ADDENDUM NO. 1

**TO
CONTRACT DOCUMENTS AND TECHNICAL SPECIFICATIONS
FOR THE
WATER TREATMENT PLANT DISINFECTION IMPROVEMENTS
IN
ANTIOCH, CALIFORNIA
P.W. 246-29**

**ISSUED
February 27, 2017**

CITY OF ANTIOCH
WATER TREATMENT PLANT DISINFECTION IMPROVEMENTS (P.W. 246-29)

**BULK CHEMICAL STORAGE AREA
DEMO PLAN**

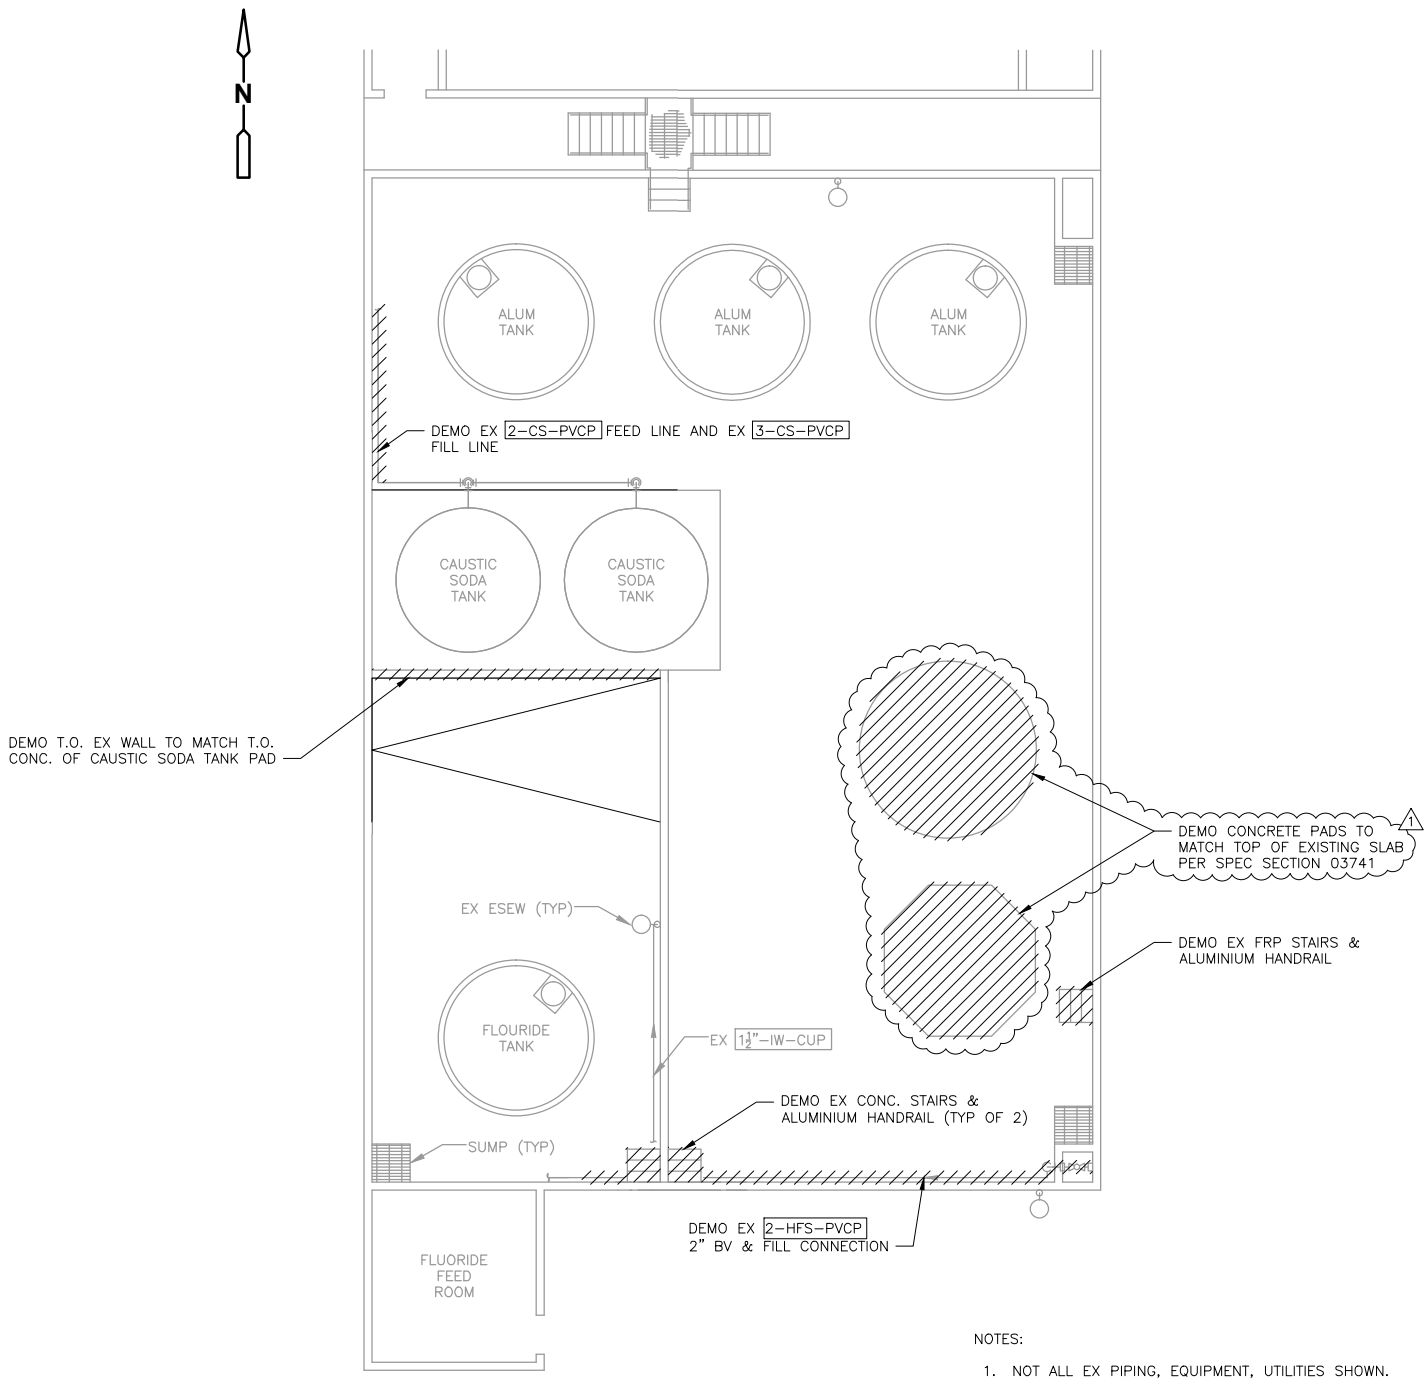
- 7. On Sheet D-1 please provide details of the wall demo at the caustic tank pad in order for us to accurately quote.***

- 12. On Sheet D-1 the existing tank equipment pads are not shown as being demolished, in fact they are not shown at all. Are these going to be demolished as part of the project or is the district going to handle this work?**

Response: Means and methods of demolition and repair of existing concrete are included in Specification Section 03741 Paragraphs 3.01 and 3.02. Top of modified concrete is noted on the structural drawings.

Response: Contractor is responsible for the demolition of the existing tank equipment pads. See modifications to Drawings below for Sheet D-1.

Delete sheet in its entirety and replace with the attached Sheet D-1.

EXTERIOR EQUIPMENT SLAB (UNO)

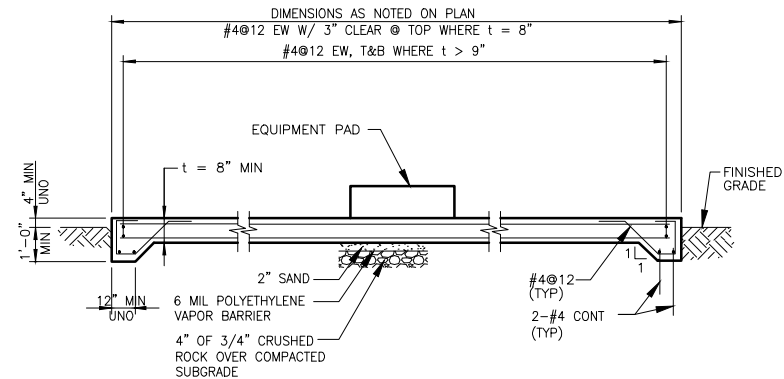
- 14. There are some electrical panels and transformers shown on sheet E-5, and it is not clear which ones are pad mounted and which ones will be support mounted. Also, I did not find a detail for an equipment pad in the asphalt. Please clarify.**

Response: See modifications to Drawings below for Sheet E-5.

Add NOTE 2: "PROVIDE NEW EQUIPMENT PADS FOR XFMR-B, XFMR-B1 AND LASCP PER DETAIL G ON SHEET SD-1."
